BROWNS FERRY NUCLEAR PLANT (BFN) – UNITS 1, 2, AND 3 - TECHNICAL SPECIFICATIONS (TS) CHANGES TS-431 AND TS-418 – EXTENDED POWER UPRATE (EPU) – RESPONSE TO ROUND 19 REQUEST FOR ADDITIONAL INFORMATION (RAI) (TAC NOS. MD5262, MD5263, AND MD5264)

TENNESSEE VALLEY AUTHORITY
BROWNS FERRY NUCLEAR PLANT (BFN)
UNITS 1, 2, AND 3

RESPONSE TO ROUND 19 REQUEST FOR ADDITIONAL INFORMATION (RAI)

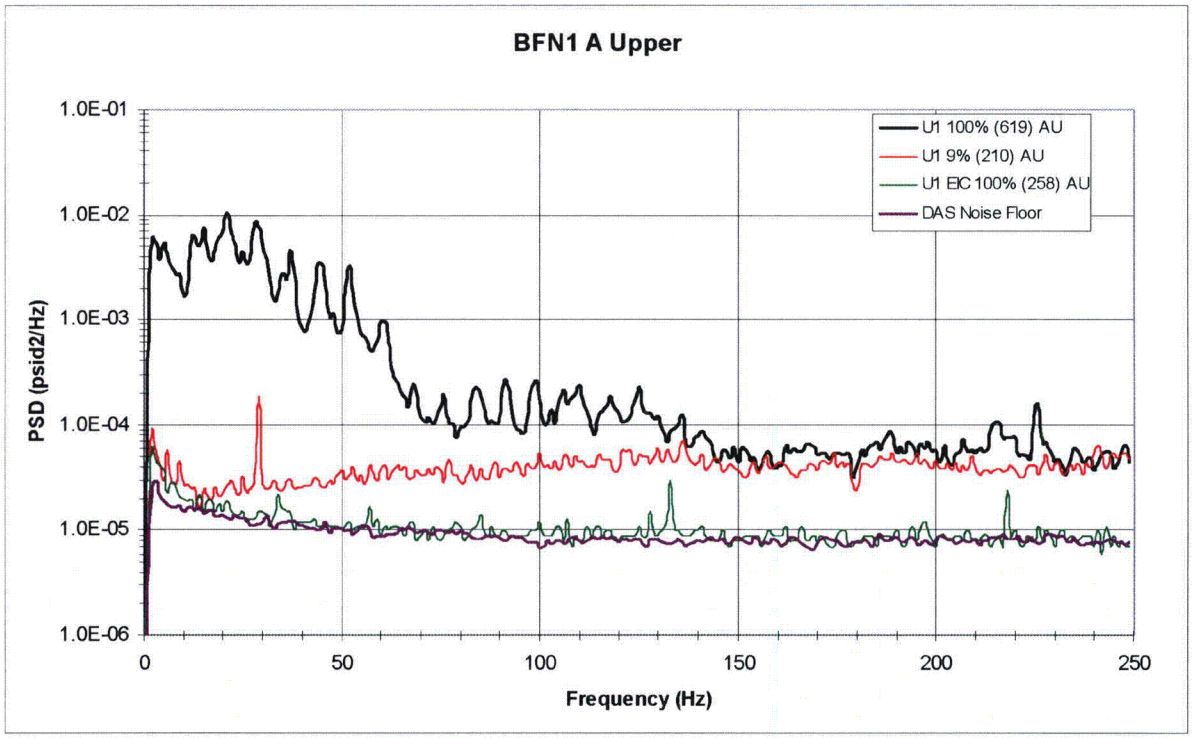
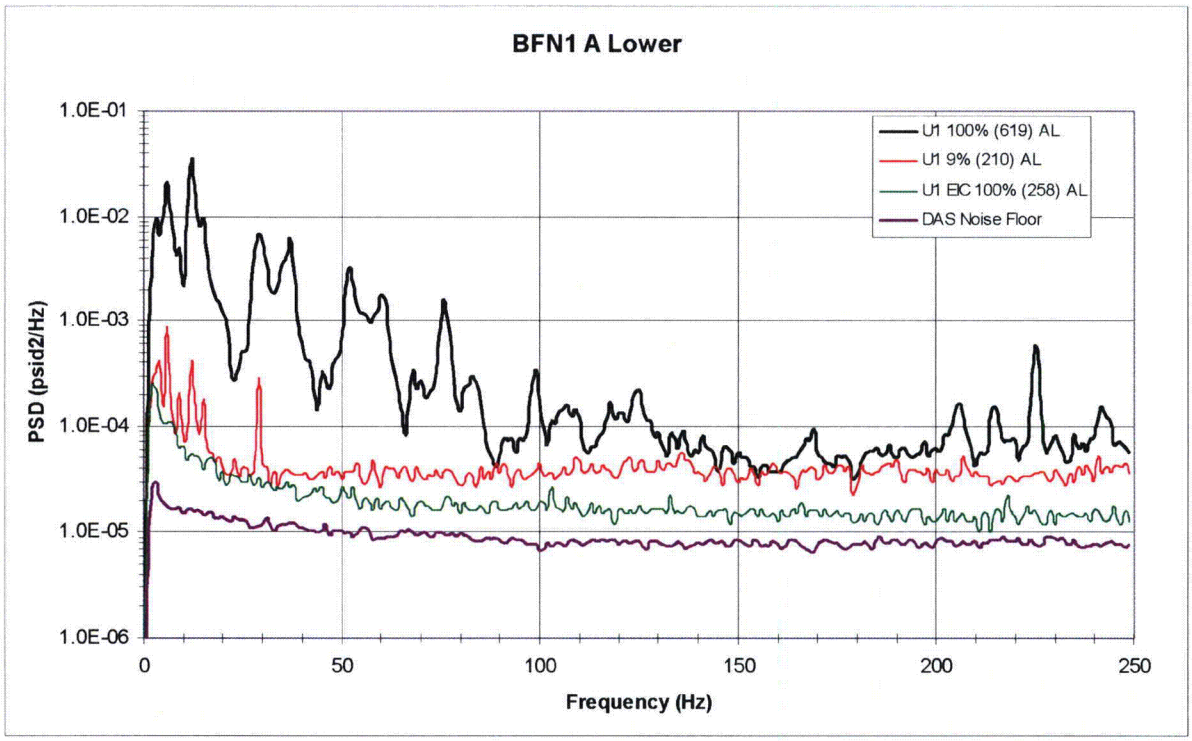
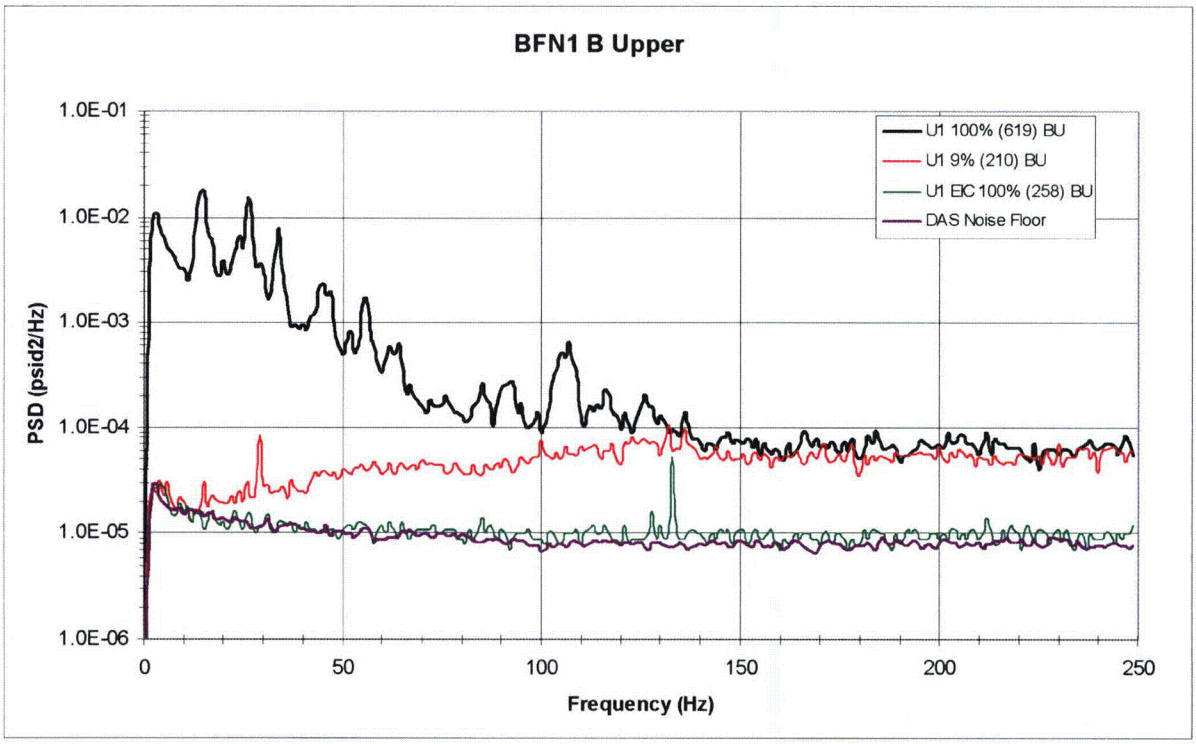
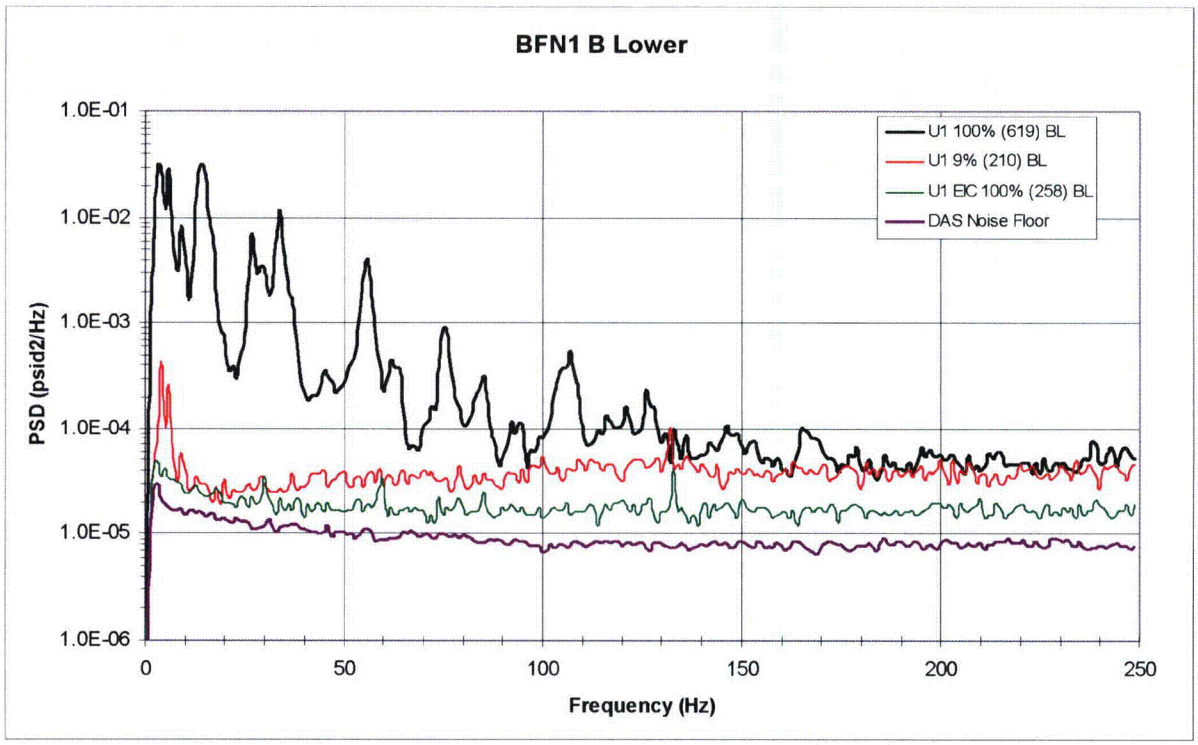
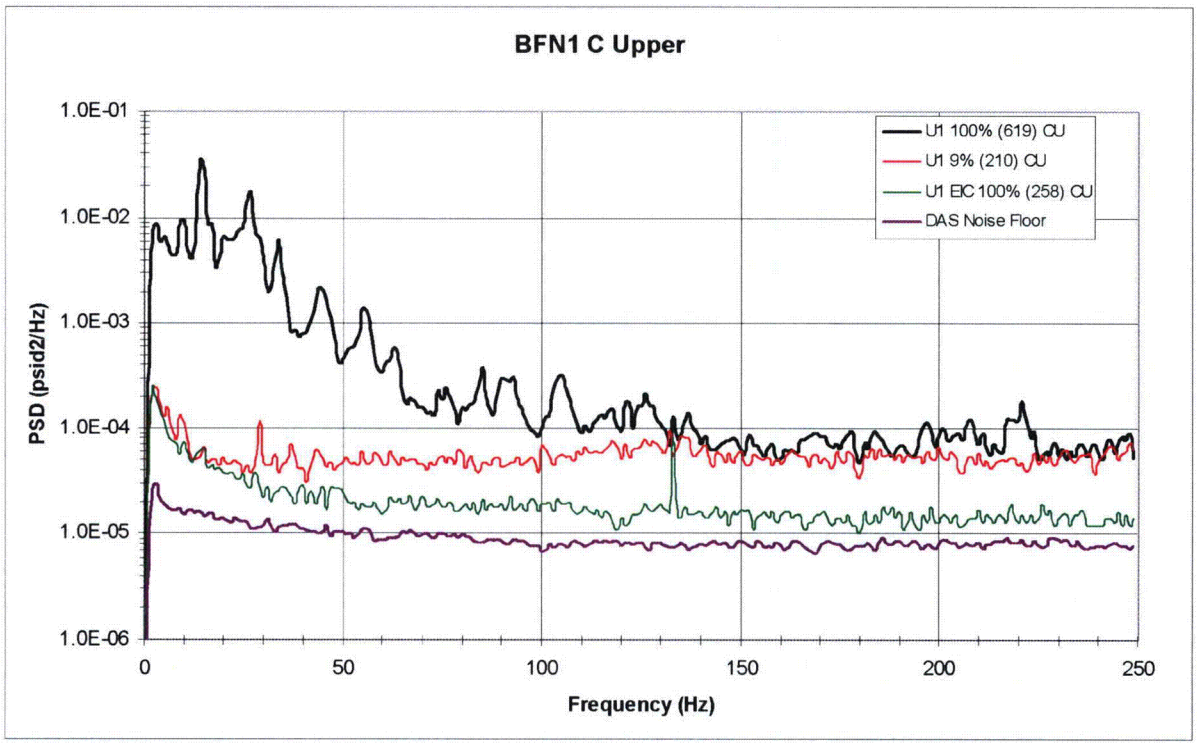
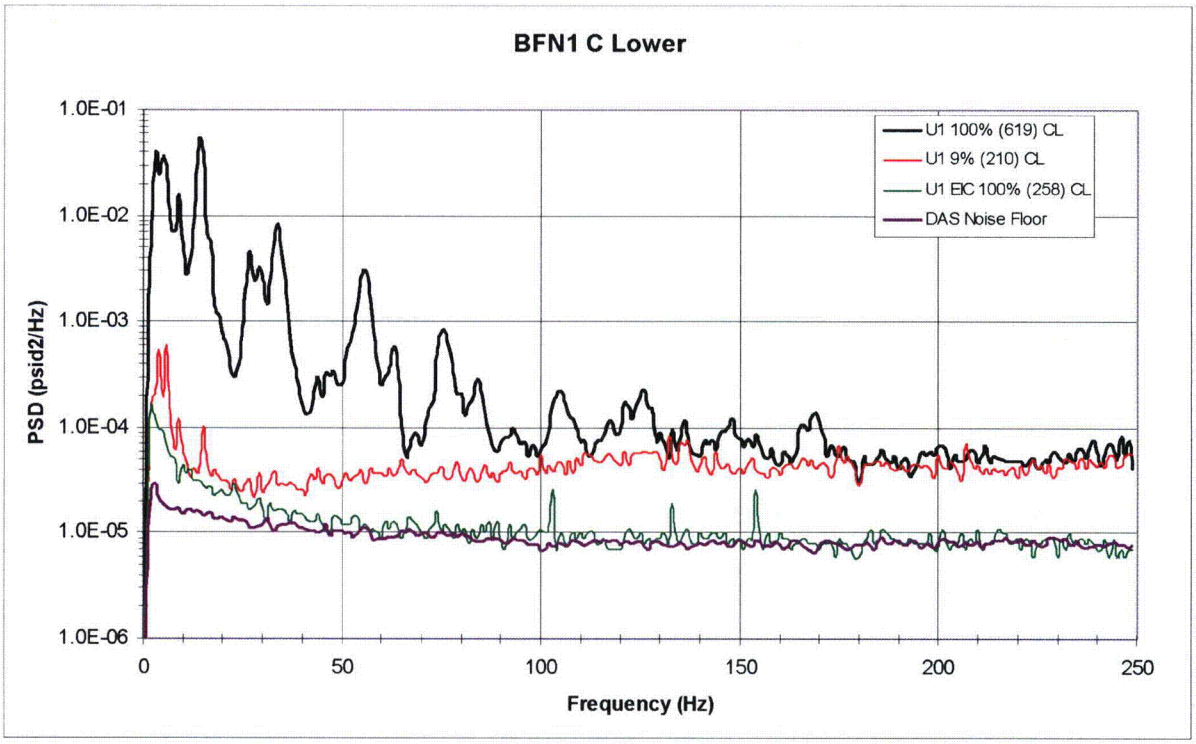
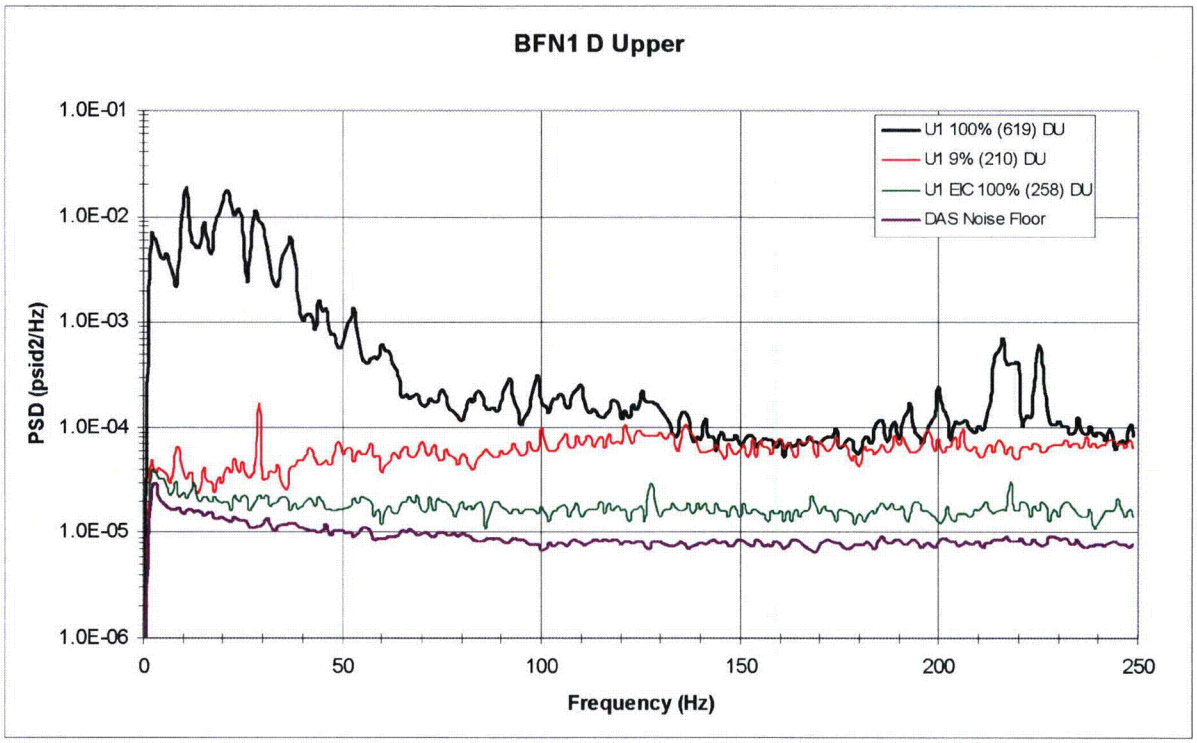
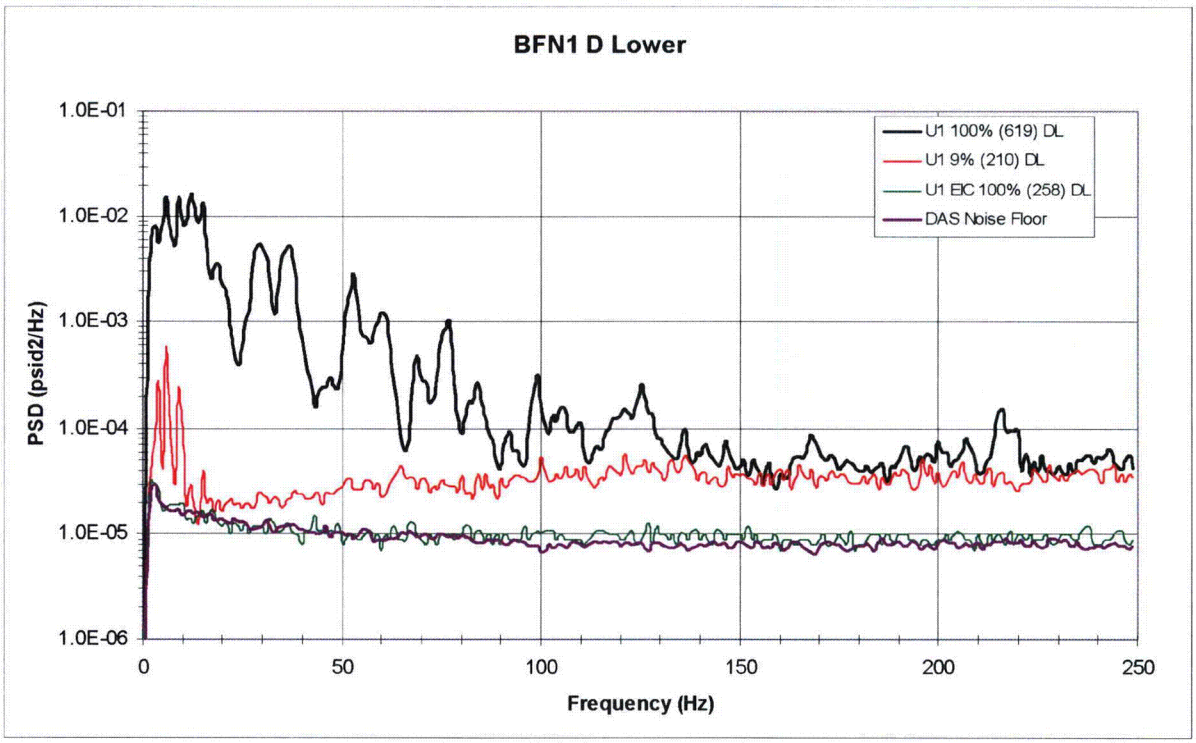
Provide data and analysis to confirm that the Unit 1 low-flow signals are actually due to plant background noise events, and not the noise floors of the sensors and data acquisition systems.

A DAS of the same type used at BFN was set up in a laboratory environment with cable and strain gages connected for the purpose of measuring the noise floor of the equipment itself. Figures EMCB.181-1a through 1e are PSD plots of the equipment noise floor as measured in the laboratory, the Unit 1 LF (9% power) data and the Unit 1 CLTP data. It can be seen that the plant noise data is well above the noise floor of the DAS and, therefore, is a valid measurement.

Figures EMCB.181-1a through 1d are PSD plots of Unit 1 signals which illustrate example signal magnitudes. The signals were filtered at the following frequencies to eliminate known noise sources.
